Road Safety Audit Stage 1

**Bartons Road Access, S278 and S38
Works, Havant**

RSA Report Ref.	Version	Date of Issue
RSA1123	Final	21/01/2026

Designer's Response to the Stage 1 Safety Audit Rev B

Problems Location Plans

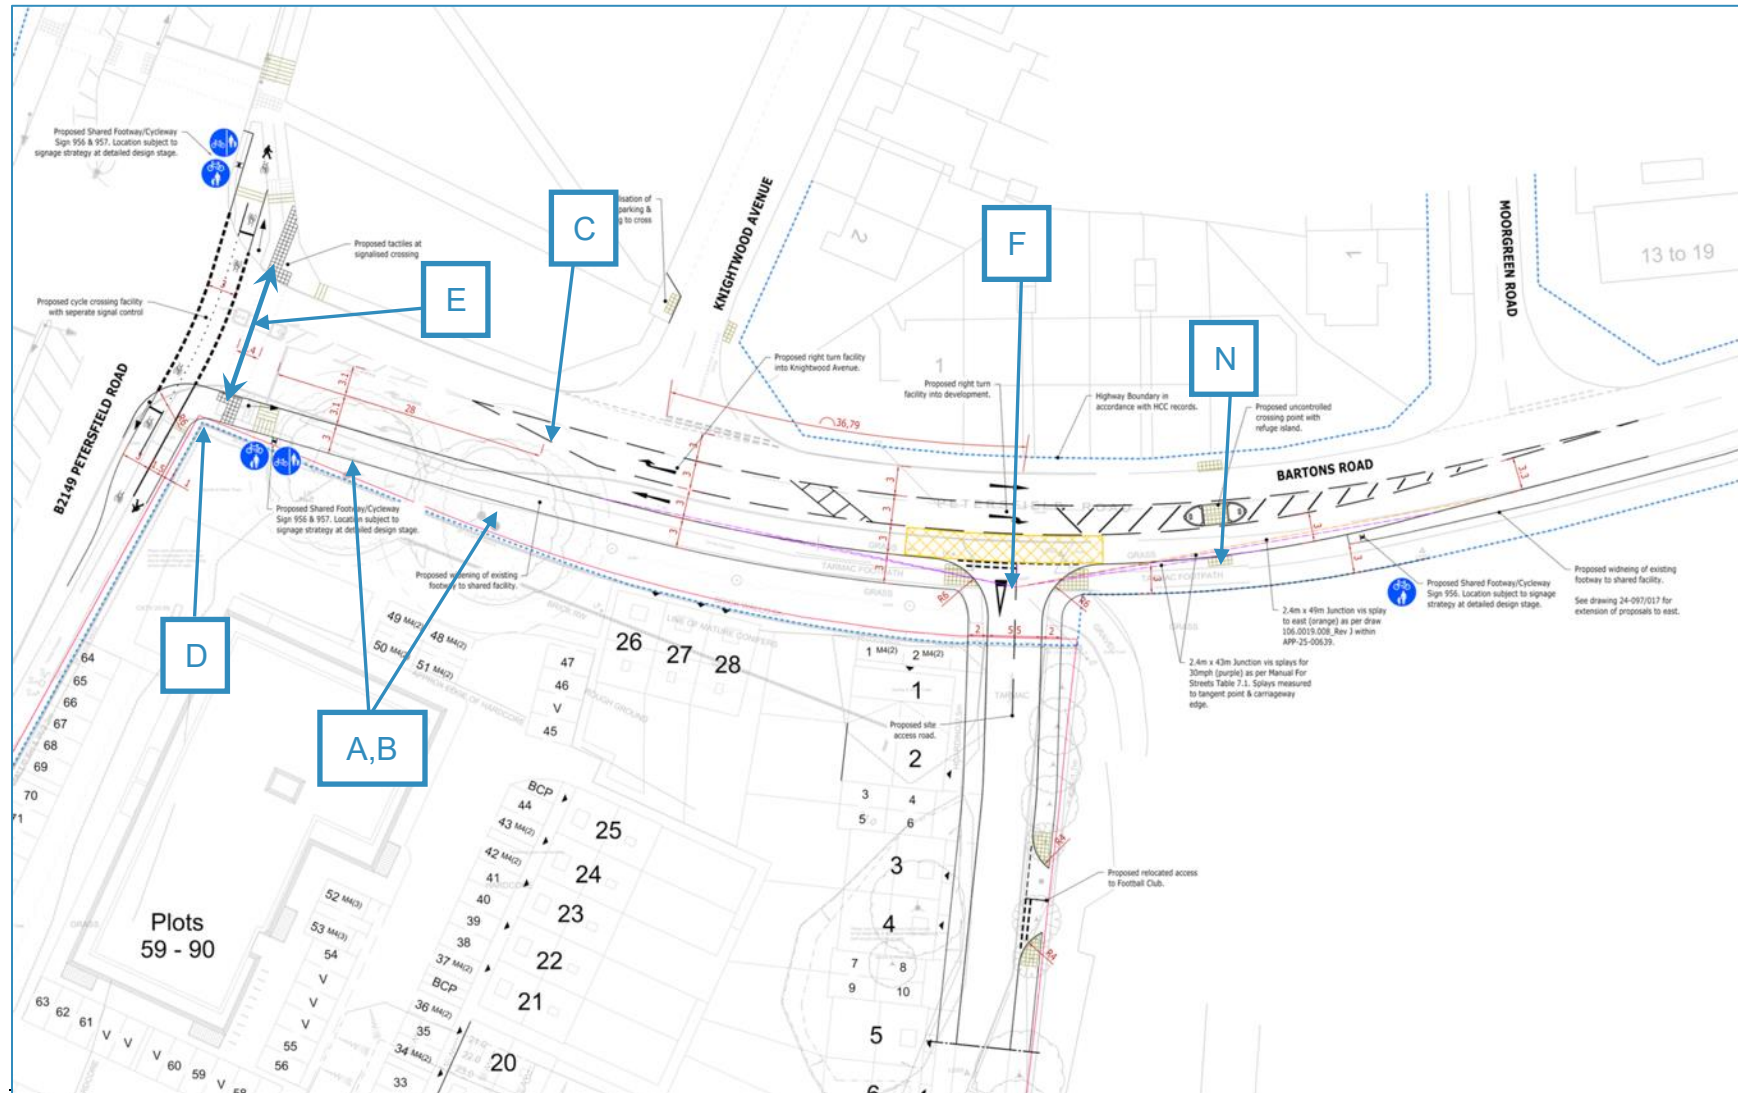
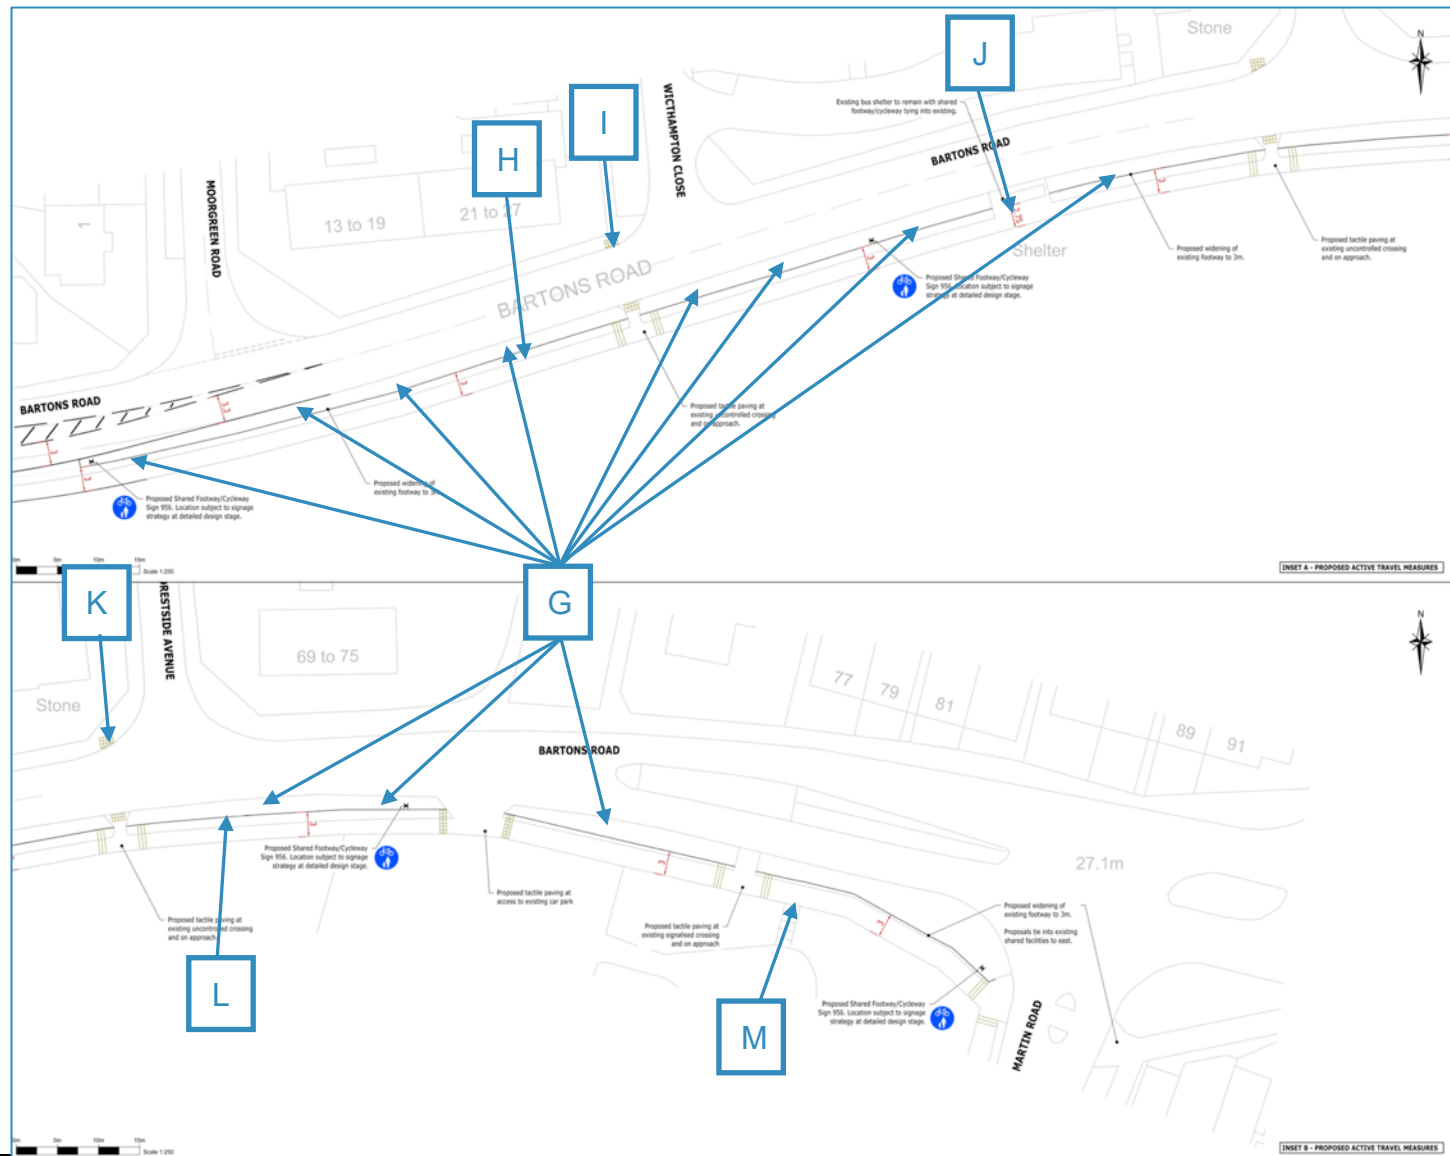
Location: A – Southern side of Bartons Road, approaching the Toucan Crossing (Dwg. 24-097/016 Rev. A).

The widened shared facility is shown passing very close to the mature trees (photo 1), the construction of which may damage the roots of the two mature trees, compromising their stability and increasing the risk of them falling onto passers-by and vehicles during periods of high wind.

Location: B – Southern side of Bartons Road, approaching the Toucan Crossing (Dwg. 24-097/016 Rev. A).

Low-hanging branches and overhanging vegetation along the southern side of Bartons Road are encroaching onto the proposed cycle path and shared-use facility (photo 2). This creates a potential hazard for cyclists, particularly those travelling at speed, who may not have sufficient time or space to react and avoid contact. The obstruction could result in collisions with the vegetation, leading to loss of control, injury, or deviation into pedestrians also using the path.

Audit Team No.	Audit Team Observation	Audit Team Recommendation	C&A Designers Response	Client Comment
3. Items resulting from this Stage 1 Audit				
3.1	<p>Problem</p> <p>Location: A – Southern Side of Bartons Road, approaching the Toucan Crossing (Dwg. 24-097/016 Rev. A).</p> <p>Summary: Risk of trees falling onto the highway.</p> <p>The widened shared facility is shown passing very close to the mature trees (photo 1), the construction of which may damage the roots of the two mature trees, compromising their stability and increasing the risk of them falling onto passers-by and vehicles during periods of high wind.</p>	<p>Recommendation:</p> <p>The tree roots should not be damaged during the construction of the widened, shared cycle/footway.</p>	<p>Agree:</p> <p>This is a matter for the detailed design stage. It will be addressed by confirming with the Arboriculturist that any minor root damage would not be detrimental to the trees. If required, a root protection system would be implemented. No changes are required at this stage.</p>

3.2	<p>Problem</p> <p>Location: B – Southern side of Bartons Road, Approaching the Toucan Crossing (Dwg. 24-097/016 Rev. A).</p> <p>Summary: Risk of injury to cyclists using the shared cycle path due to overhanging vegetation.</p> <p>Low-hanging branches and overhanging vegetation along the southern side of Bartons Road are encroaching onto the proposed cycle path and shared-use facility (photo 2). This creates a potential hazard for cyclists, particularly those travelling at speed, who may not have</p>	<p>Recommendation:</p> <p>It is recommended that the overhanging branches and vegetation be cut back to provide clear and unobstructed headroom along the full length of the proposed facility. A regular maintenance regime should also be implemented to ensure vegetation does not re-encroach into the path in the future.</p>	<p>Agree:</p> <p>Overhanging branches and vegetation should be regularly trimmed by LHA to maintain clear and unobstructed headroom along the full length of the proposed shared footway/cycleway.</p>

24-097/016

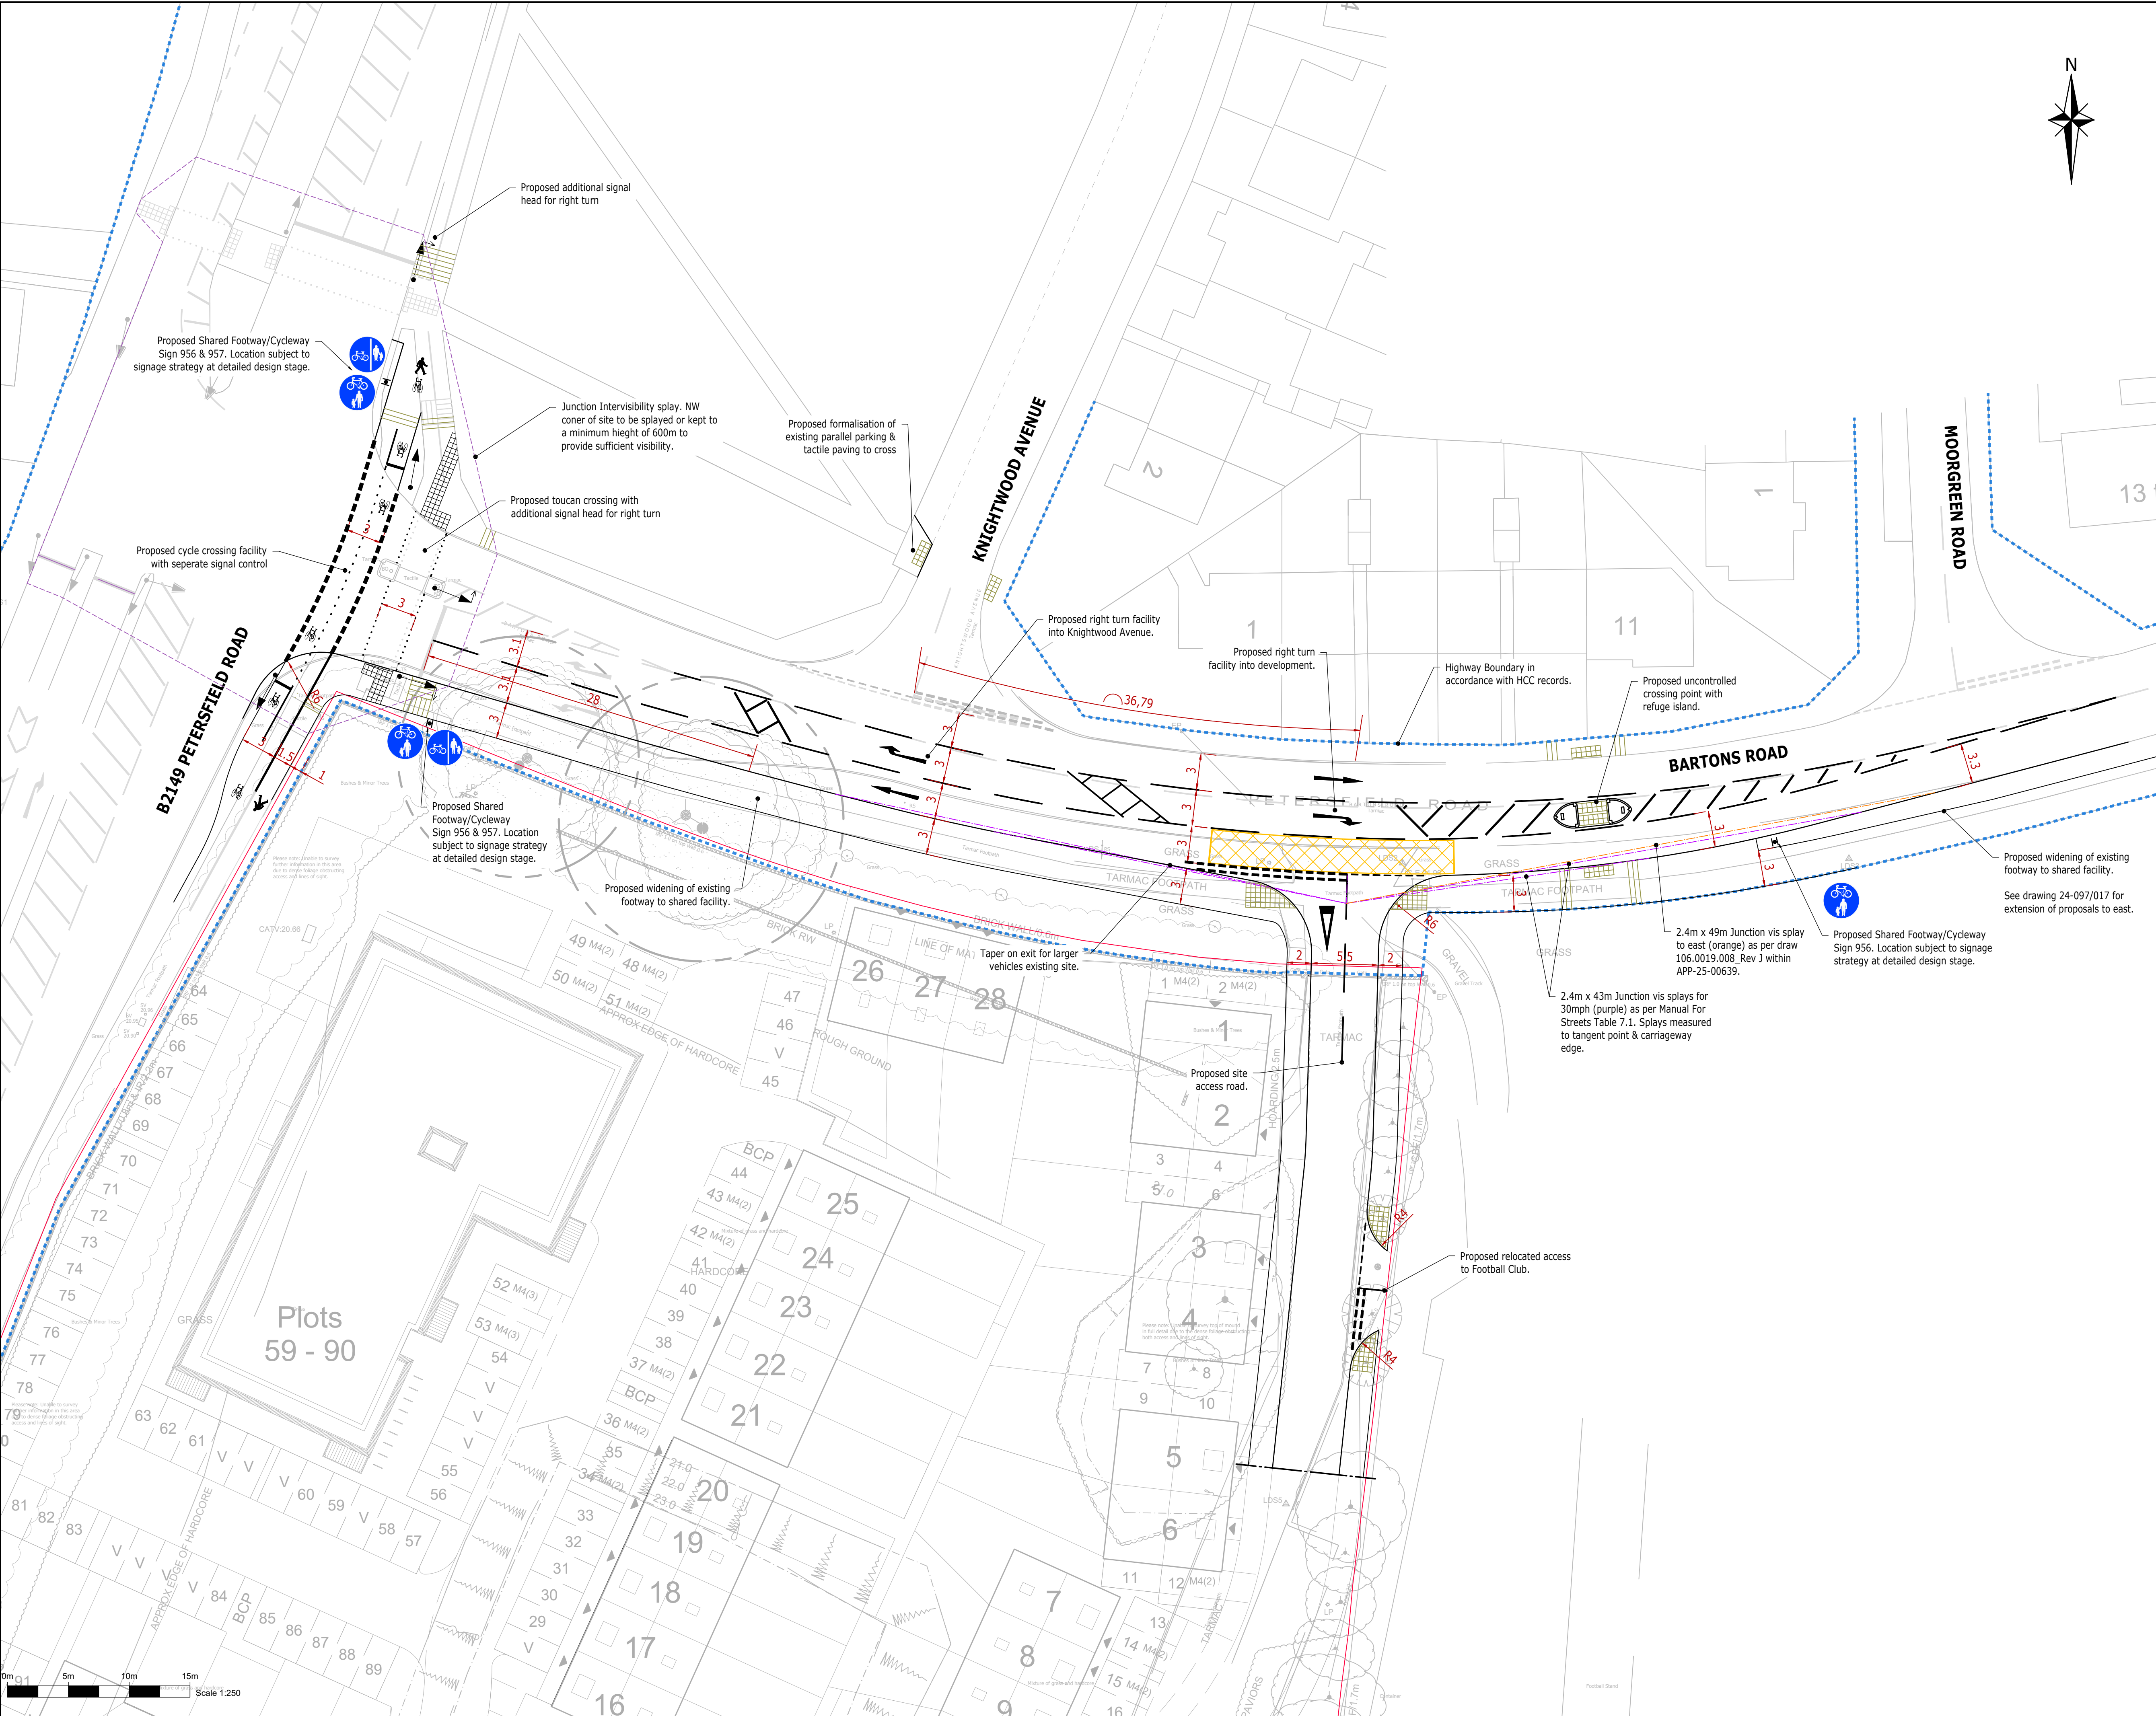
The single, angled road marking separating the two right turn pockets does not give sufficient guidance to vehicles using each of the pockets. The likelihood is that the queue for the right turn into Petersfield Road will extend into the right turn pocket for Knightwood Avenue. A driver heading to turn right into Petersfield Road may sit behind the left turn queue if they have not reached the angled line that shows the start of the right turn lane. However, a following vehicle may decide to queue for the right turn into Petersfield Road in the Knightwood Avenue right turn pocket. If the first driver changes their mind and decides to swap into the Knightwood Avenue pocket whilst the second vehicle is arriving the risk of a side swipe impact increases.

Hatched markings, similar to those proposed between the Knightwood Avenue and development right turn lanes, should be used at the western end of the Knightwood Avenue pocket, where the Petersfield Road right turn lane commences.

The corner of the site boundary fence interjects into the junction intervisibility zone, the zone safeguarding late users of a stage when the following stage of the signal cycle is commencing. The cycle crossing will, no doubt, require its own stage within the signal cycle but if the Barton Road stage follows the cycle crossing stage, a late northbound cyclist, thinking that they still have still in the intergreen to cross Barton Road, may be struck by a Barton Road left turning vehicle jumping the opening amber/green signal because they can see no traffic or pedestrians moving at the junction.

The fence at the north-west corner of the development site should be relocated so that a full standard junction intervisibility zone can be provided that includes the cycle facility across the mouth of Barton Road.

Summary: The relatively narrow width of the development access road, combined with the relatively small shoulder radii, means that large vehicles will have to encroach into the right turn lane when turning left from the development road. Large vehicles turning into the development will also have to cross onto the opposing lane. In both cases the risk of head-on collisions increases, as does the risk of rear shunt collisions as vehicles brake hard to avoid a head-on collision.

A swept path analysis for large vehicles should be carried out at the development access junction and the design altered accordingly to reduce the risk of vehicle encroachment into opposing lanes as they turn left to and from the access.

3.3	<p>Problem</p> <p>Location: C – Right turn lane into Knightwood Avenue and Petersfield Road (Dwg. 24-097/016 Rev. A).</p> <p>Summary: Risk side swipe collisions.</p> <p>The single, angled road marking separating the two right turn pockets does not give sufficient guidance to vehicles using each of the pockets. The likelihood is that the queue for the right turn into Petersfield Road will extend into the right turn pocket for Knightwood Avenue. A driver heading to turn right into Petersfield Road may sit behind the left turn queue if they have not reached the angled line that shows the start of the right turn lane. However, a following vehicle may decide to queue for the right turn into Petersfield Road in the Knightwood Avenue right turn pocket. If the first driver changes their mind and decides to swap into the Knightwood Avenue pocket whilst the second vehicle is arriving the risk of a side swipe impact increases.</p>	<p>Recommendation:</p> <p>Hatched markings, similar to those proposed between the Knightwood Avenue and development right turn lanes, should be used at the western end of the Knightwood Avenue pocket, where the Petersfield Road right turn lane commences.</p>	<p>Agree:</p> <p>The hatched marking to be provided the western end of the Knightwood Avenue as shown in updated Drawing 24-097/016 Rev B.</p>

3.4	<p>Problem</p> <p>Location: D – Bartons Road/Petersfield Road junction - the southern end of the Cycle crossing (Dwg. 24-097/016 Rev. A).</p>	<p>Recommendation:</p> <p>The fence at the north-west corner of the development site should be relocated so that a full standard junction intervisibility zone can be</p>	<p>Agree:</p> <p>The fence at the north-west corner of the site will be removed or height will be limited to a maximum of 600 mm, ensuring adequate intervisibility between cyclists and vehicles during</p>

3.6	<p>Problem</p> <p>Location: F – The development junction (Dwg. 24-097/016 Rev. A).</p> <p>Summary:</p> <p>The relatively narrow width of the development access road, combined with the relatively small shoulder radii, means that large vehicles will have to encroach into the right turn lane when turning left from the development road. Large vehicles turning into the development will also have to cross onto the opposing lane. In both cases the risk of head-on collisions increases, as does the risk of rear shunt collisions as vehicles brake hard to avoid a head-on collision.</p>	<p>Recommendation:</p> <p>A swept path analysis for large vehicles should be carried out at the development access junction, and the design should be carried out at the development access junction and the design altered accordingly to reduce the risk of vehicle encroachment into opposing lanes as they turn left to and from the access.</p>	<p>Agree:</p> <p>In order to minimise the impact of larger vehicles encroaching onto opposing lanes a small taper on the site access road exit has been introduced. This does not fully prevent encroachment from refuse vehicles for example, however, it ensures that more regular delivery vehicles can be accommodated safely.</p> <p>Disagree:</p> <p>Although large vehicles still partially encroach into the opposing lane when turning due to the access width and corner radii, the associated risk is considered low.</p> <p>Large vehicle movements for the development will be limited primarily to refuse vehicles, which are expected to access the site infrequently (once per week) and fire vehicle during unforeseen circumstances only.</p> <p>Swept path analysis indicates that any overhang into the opposing lane is minimal and would occur at low speeds, during quieter periods and within a controlled access environment with adequate visibility.</p>

<p>Providing increased road width or larger radii to fully accommodate these infrequent movements would be disproportionate and over-engineered.</p> <p>Furthermore, the proposed access arrangement mirrors closely the scheme previously agreed with HCC as part of application 20/00658 on the site.</p>
